**STATE OF HAWAII  
DEPARTMENT OF TRANSPORTATION  
HIGHWAYS**

**ADDENDUM NO. 1  
FOR  
INTERSTATE ROUTE H-1, MCCULLY STREET SEPARATION,  
SEISMIC RETROFIT  
FEDERAL-AID PROJECT NO. NH-H1-1(284)  
DISTRICT OF HONOLULU  
ISLAND OF OAHU**

**May 1, 2026**

INTERSTATE ROUTE H-1  
MCCULLY STREET SEPARATION  
SEISMIC RETROFIT  
Federal-Aid Project No. NH-H1-1(284)  
Scale: 1" = 1'-0" Date: March 2026

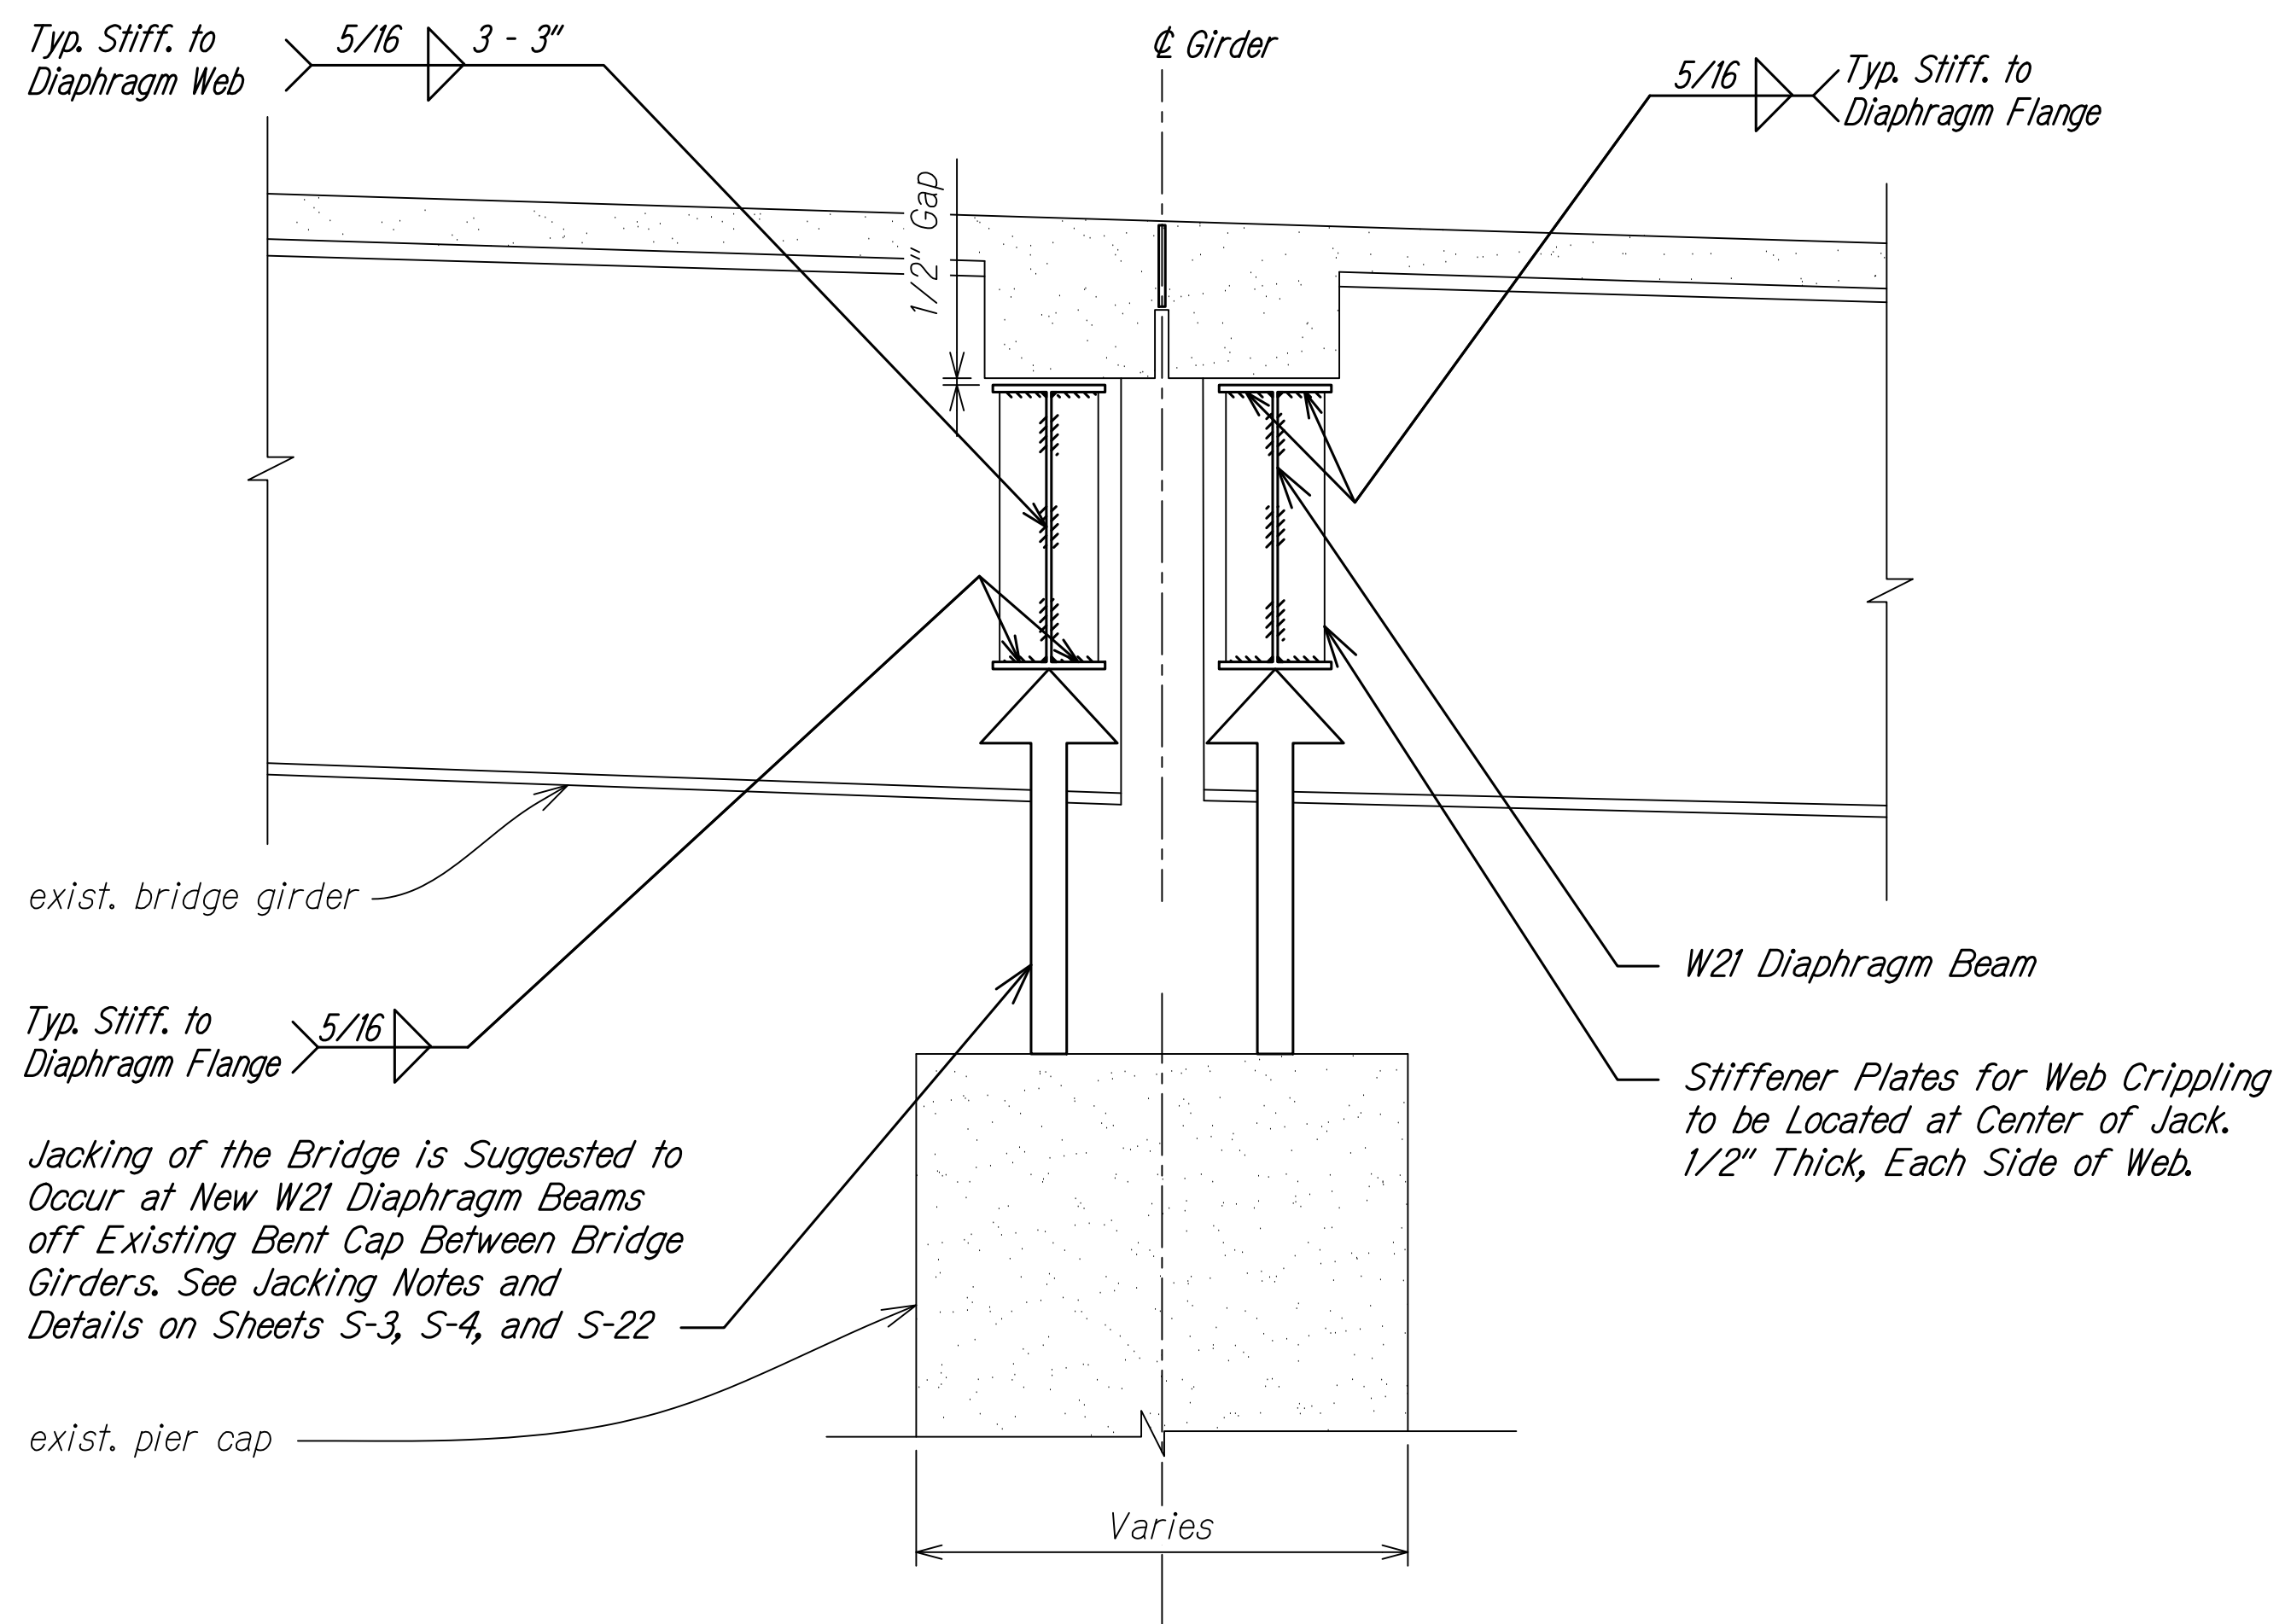
4/21/26	1	Added grout pad extension dimension.
DATE		REVISION

- Note:**
- Leveling nuts are not shown for clarity. See Detail B/S-23.
  - The seat extension design for Pier 4 differs from this view. See Sheet S-27 for detailing and dimensions.
  - Grout pad shall extend a minimum of 1 1/2" horizontally on all sides of the bearing.

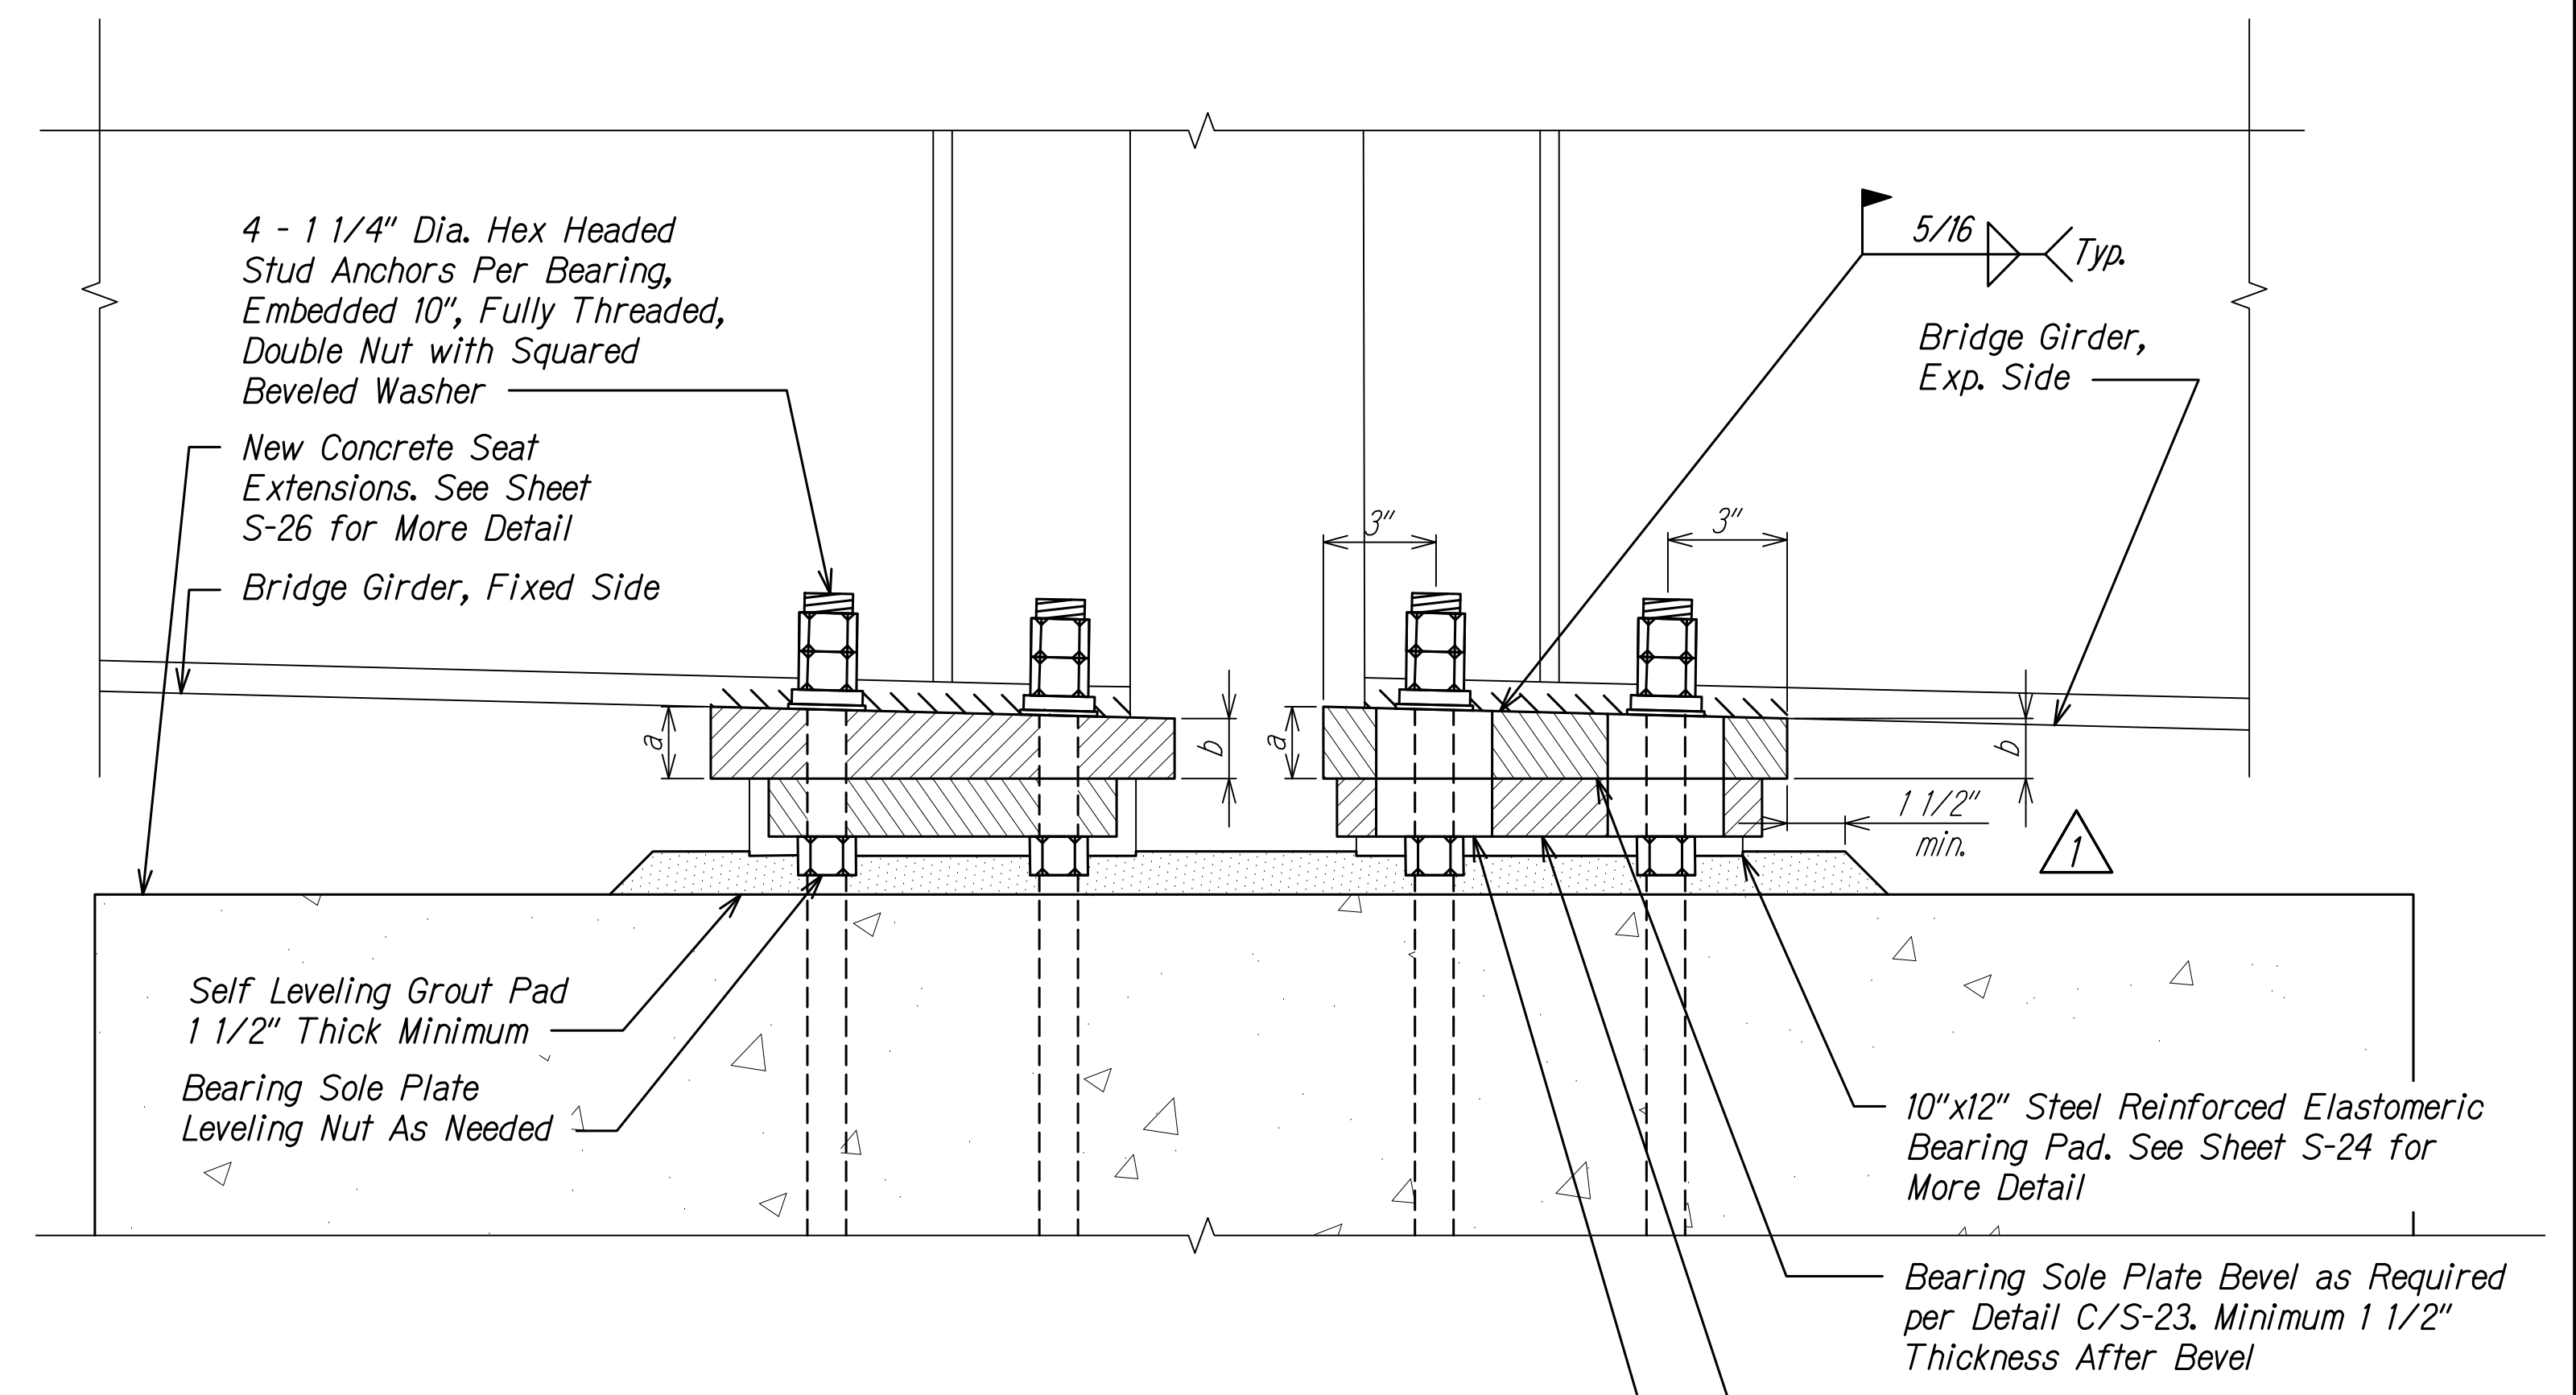
4/21/26	1	Added grout pad extension dimensions.
DATE	REVISION	
STATE OF HAWAII DEPARTMENT OF TRANSPORTATION HIGHWAYS DIVISION		
<b>JACKING SECTION AND BEARING BEVEL DETAIL</b>		
INTERSTATE ROUTE H-1 MCCULLY STREET SEPARATION SEISMIC RETROFIT		
Federal-Aid Project No. NH-HI-1(284)		
Scale: As Noted		Date: March 2026
SHEET No. S-23 OF 29 SHEETS
